Model: Model AP-P1	Date: 29-Sep-06	No.: RG133001k
--------------------	-----------------	----------------

Subject: Firmware Release Note: System		Prepared by: M.Kumagai	
From: 1st Overseas Tech Support Sec., 1st PQM Dept.			
Classification:	<input type="checkbox"/> Troubleshooting	<input type="checkbox"/> Part information	<input type="checkbox"/> Action required
	<input type="checkbox"/> Mechanical	<input type="checkbox"/> Electrical	<input type="checkbox"/> Service manual revision
	<input type="checkbox"/> Paper path	<input type="checkbox"/> Transmit/receive	<input type="checkbox"/> Retrofit information
	<input checked="" type="checkbox"/> Other ()

This RTB has been issued to announce the firmware release information for the **System**.

Procedure for Attaching the Spring

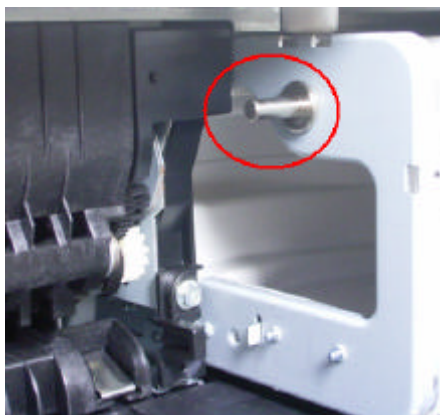
Parallel horizontal lines on the original are not parallel on the printout (they are separated by more than 2.5mm),

Sometimes, the paper is not transported between the transport roller and fusing roller perfectly straight.

Attach a spring to one of the stud pins (**see the procedure below**).

1. If the horizontal line on the printout slopes **down to the left**, attach the spring to the **operator side** pin.

2. If the horizontal line on the printout slopes **down to the right**, attach the spring to the **non-operator side** pin.

3. Make 10 printouts and check the image quality.
4. If the symptom still occurs, try one of the other springs listed above.

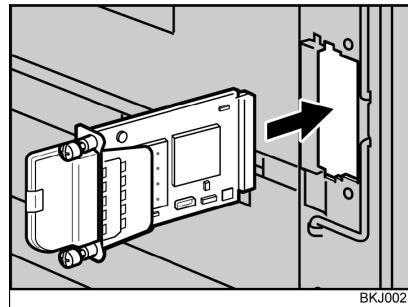
Previous types:
PCB, LAN card, and cover are
separate

New Type (IEEE802.11b
Interface Unit Type N):
Pre-assembled

41.Electrical Section 3 (B222/B224)

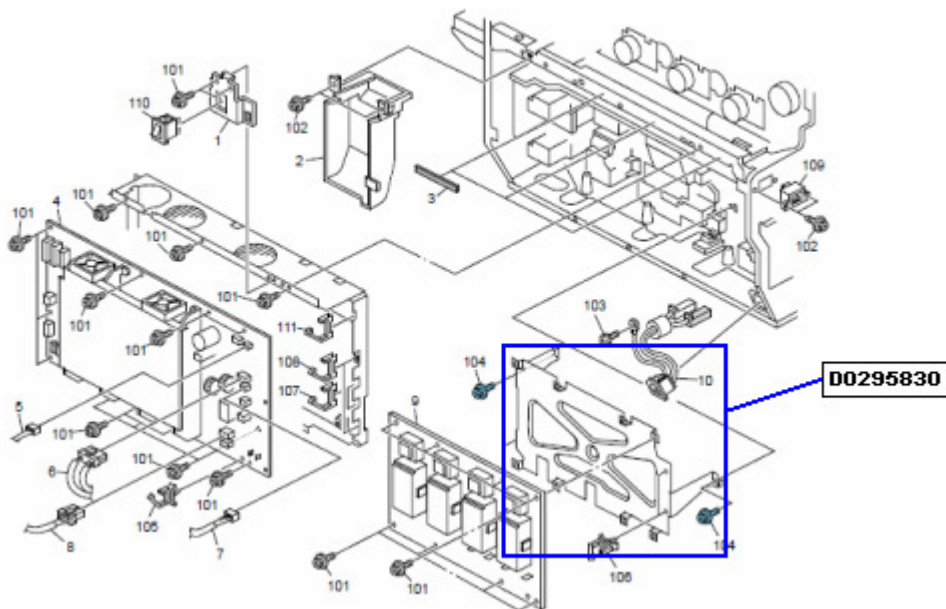
Change / Reason: The power pack bracket was added to the parts catalog.

Old part number	New part number	Description	Q'ty	Int	Page	Index	Note
	D0295830	BRACKET:POWER PACK:PEEN	1		61

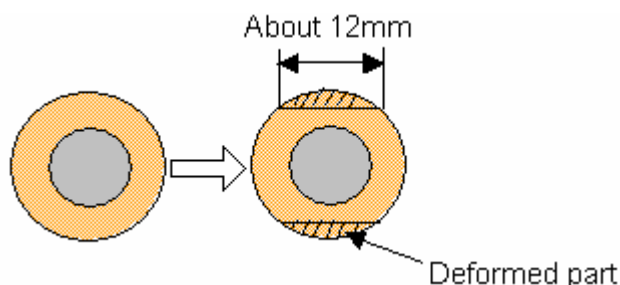
1. Double images or uneven image density in solid image areas (color).
2. A rattling sound can be heard coming from the fusing unit.

The machine is used under the following conditions, which minimizes the frequency at which the fusing roller is rotated/idled. Also, the idling home position is constant. As a result, the same area of the fusing roller surface is exposed to the heating roller for long periods of time, which flattens out this area.

1. Replace the fusing roller.
2. Change **SP1115-002** from a setting of 0.7s to **0.9s**.

At the next service visit, change **SP1115-002** from a setting of 0.7s to **0.9s**.

***New Index**

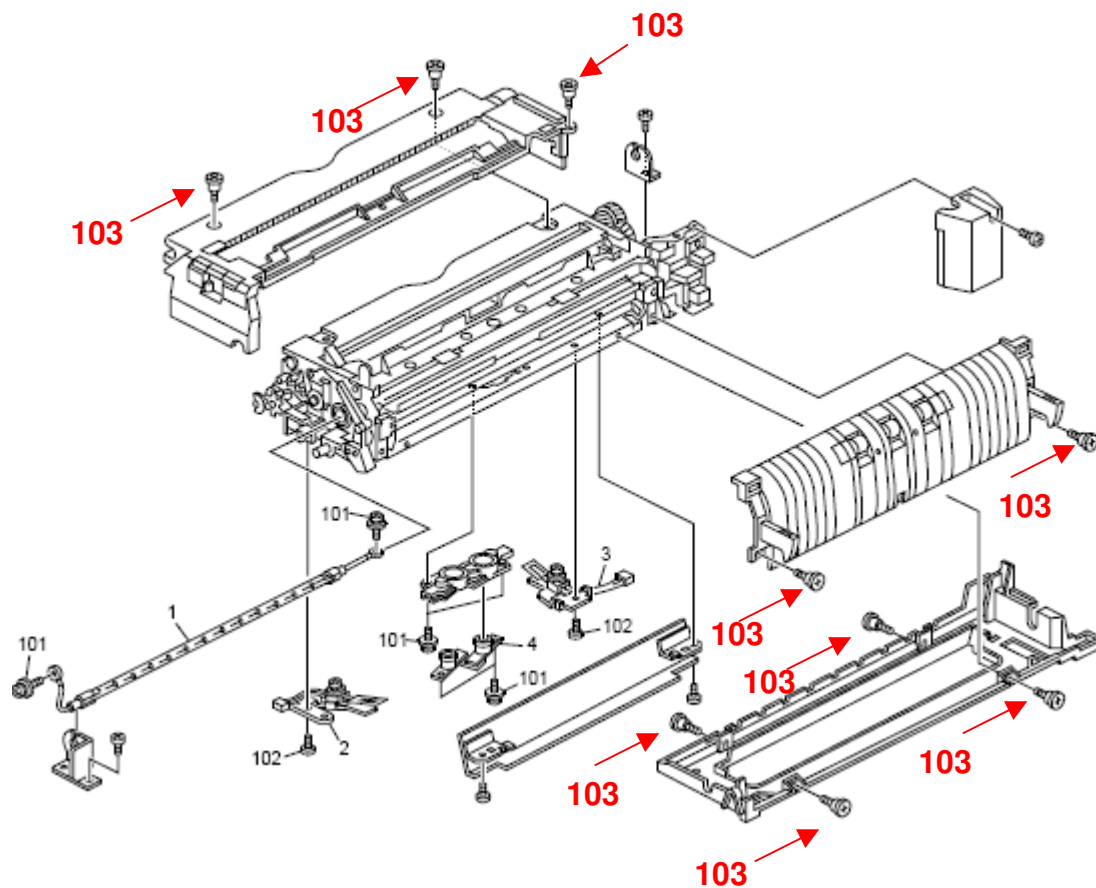
Change/Reason: The following part was missing from the parts catalog.

New part number	Description	Q'ty	Int	Page	Index	Note
AA143867	SCREW:DIA4:M3:FUSING UNIT	9		36	103

20.Duplex Unit 2 (G133)

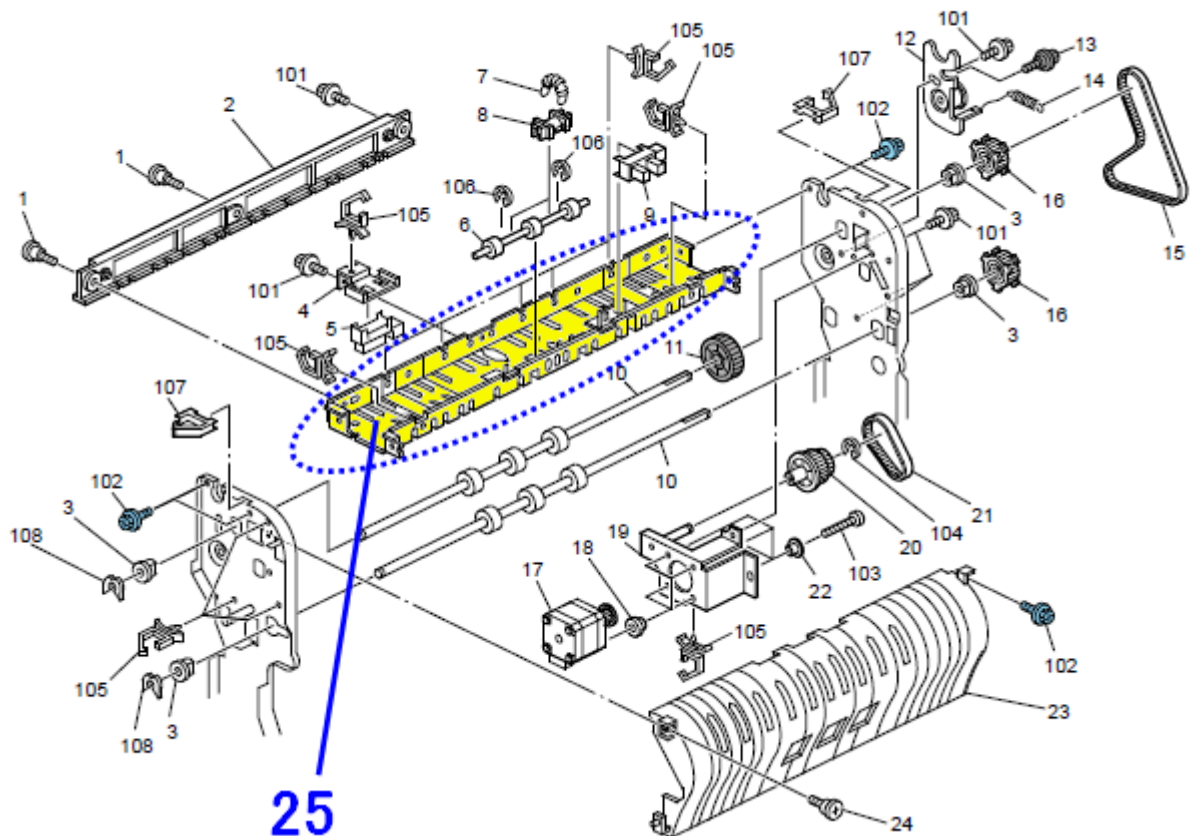
Change/Reason: The following part was missing from the parts catalog.

New part number	Description	Q'ty	Int	Page	Index	Note
B2234567	STAY:TRANSPORT:UPPER:PEEN	1		49	25*

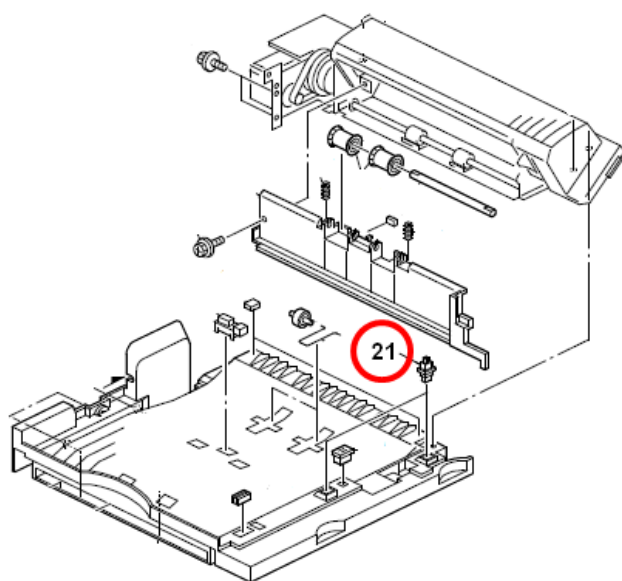
Jam 1 (Cover open) occurs frequently in the BU3000 Bridge unit.

If you replace the push switch in the red circle below, this symptom still occurs.

Because of the following two reasons, the push switch mistakenly detects a “cover open” when paper exits

Install the following **Engine Firmware** version or later, in which the push switch detection timing is changed.

Model	Version	Program No.
AP-P1	1.23:01	G1335163N

IMPORTANT SAFETY INFORMATION about the Controller Board Cover

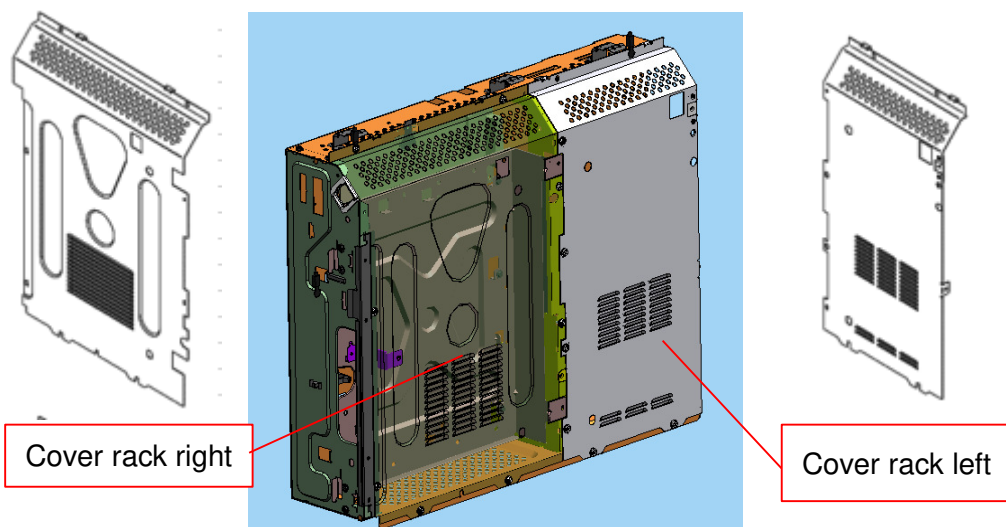
Take caution **when removing the controller board cover**, as the edges of the cover are sharp.
